PETER AND MARY BERCE RENOVATION
 6 AUTUMN LANE
 PORTLAND, MAINE 04103
 MAY 16, 2014 / REVISED JUNE 4, 2014
 JUNE 10, 14, JUNE 26, 2014, JULY 10,

A1 Floor Plan

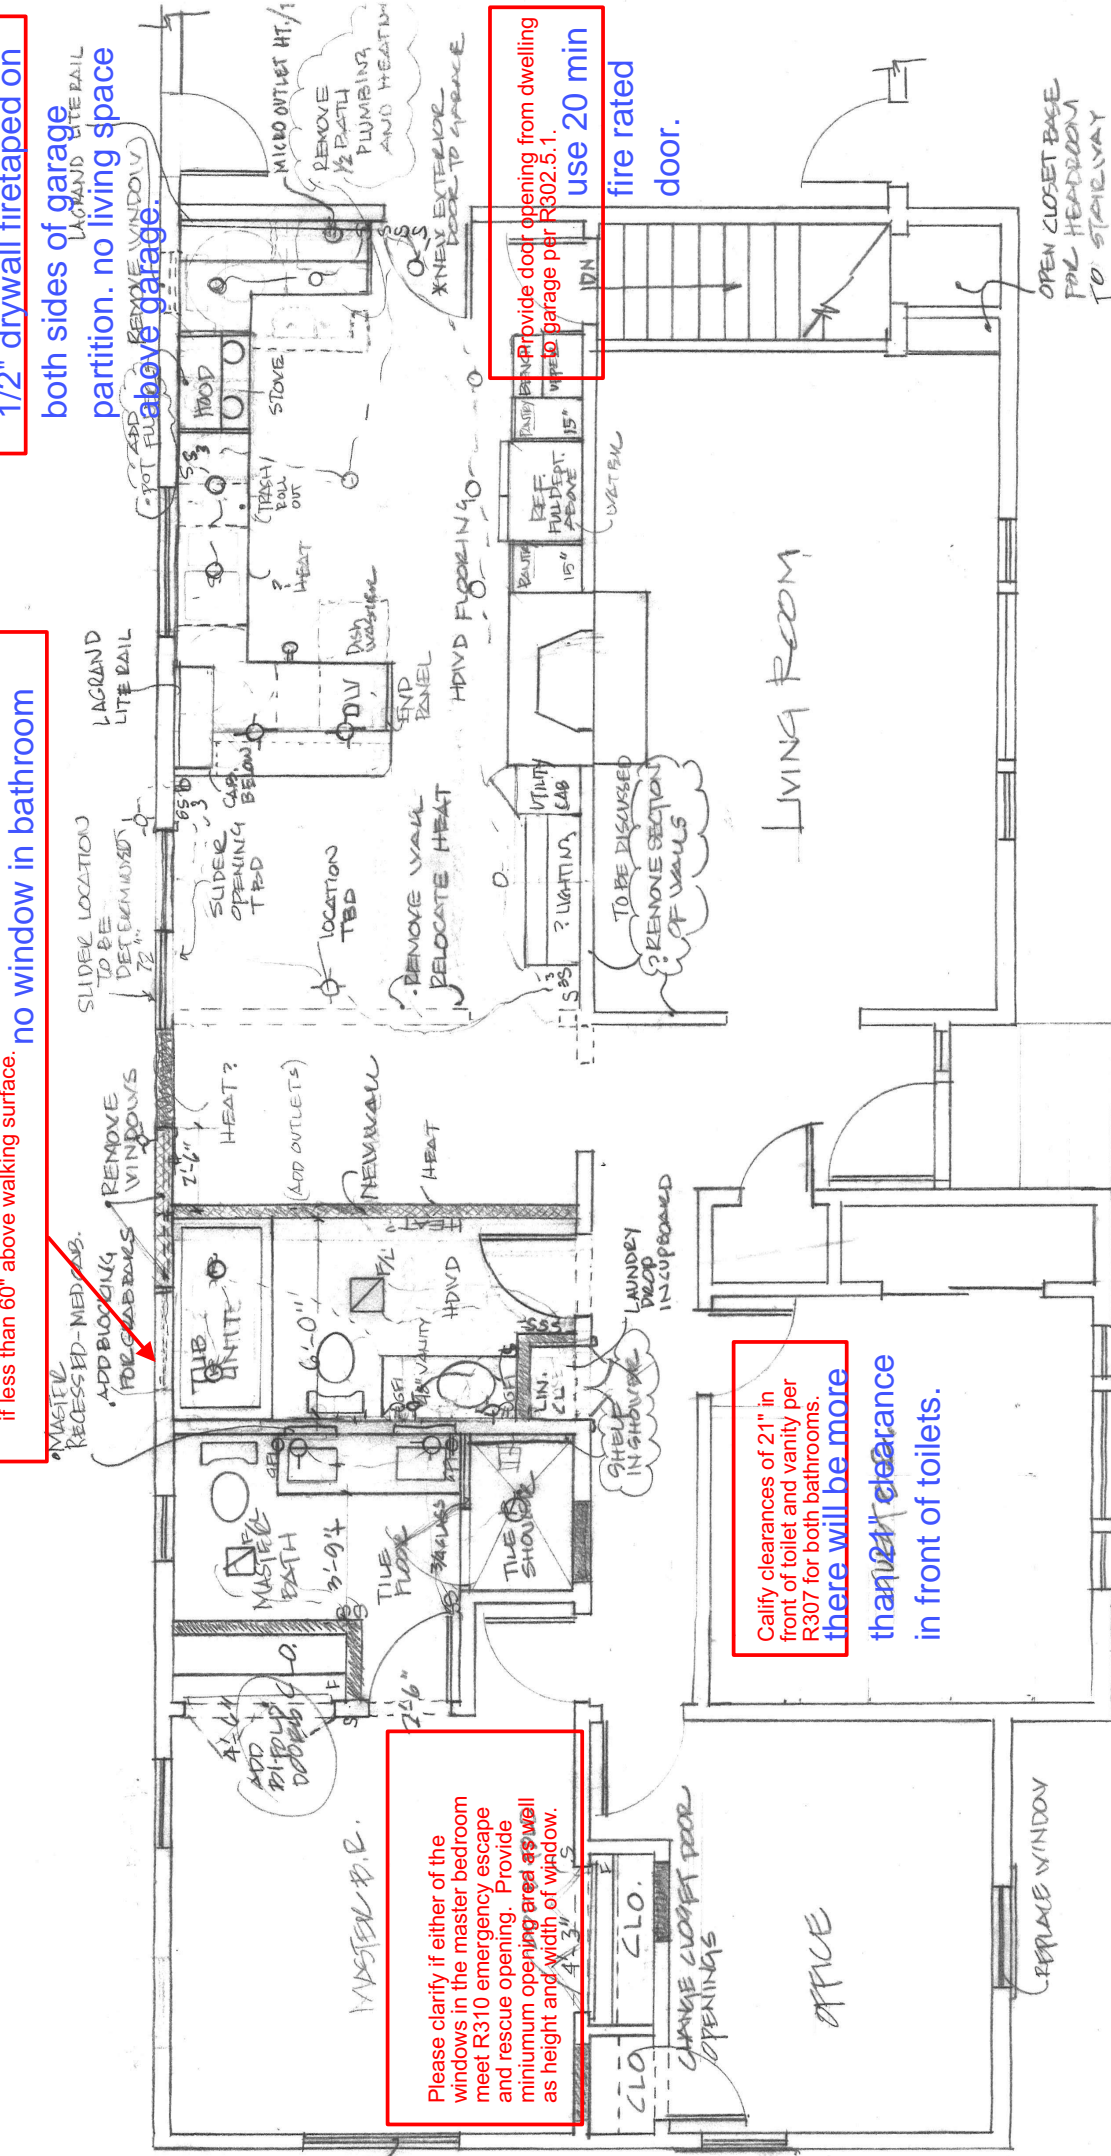
Clarify if there will be a window in bathroom. If so, clarify if window meets R308.4 hazardous conditions. Window requirement to be tempered glass if less than 60" above walking surface.

Clarify if dwelling/garage separation is per Table R302.6.

Please clarify if either of the windows in the master bedroom meet R310 emergency escape and rescue opening. Provide minimum opening area and width of window.

Provide door opening from dwelling to garage per R302.5.1.

Clarify clearances of 21" in front of toilet and vanity per R307 for both bathrooms. **there will be more than 21" clearance in front of toilets.**

no window in bathroom

1/2" drywall firetaped on

both sides of garage partition. no living space above garage.

use 20 min fire rated door.
